INTRODUCTION

OUTLINE OF NEW FEATURES

The following changes are made for the 2011 model year.

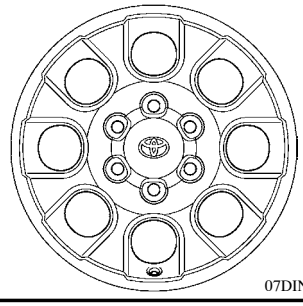
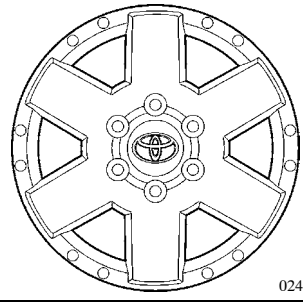
3. Tire and Disc Wheel

- The wheel lock used on the spare tire carrier on Mexican package models has been discontinued.
- The 17 inch aluminum wheel design has been changed.
- The 16 inch aluminum wheel has been discontinued.

Models		New	Previous
Tire Size		P265/70R17, 265/70R17*2	←
Wheel	Size	17 × 7 1/2J	←
	Material	Aluminum	←
P. C. D.*1	mm (in.)	139.7 (5.5)	←
Inset	mm (in.)	15 (0.6)	←
Design		 07DIN401S	 0240MO09C

▶ Layout example of indicator and warning lights ◀

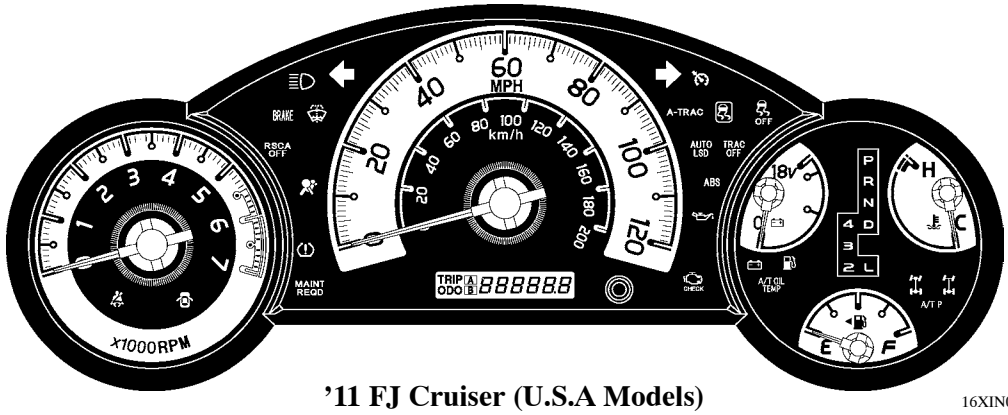
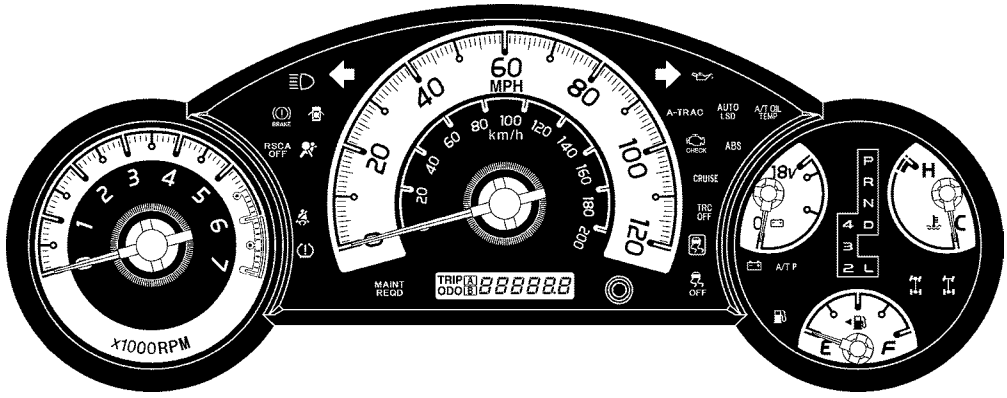
- The location of all indicator and warning lights has been changed.
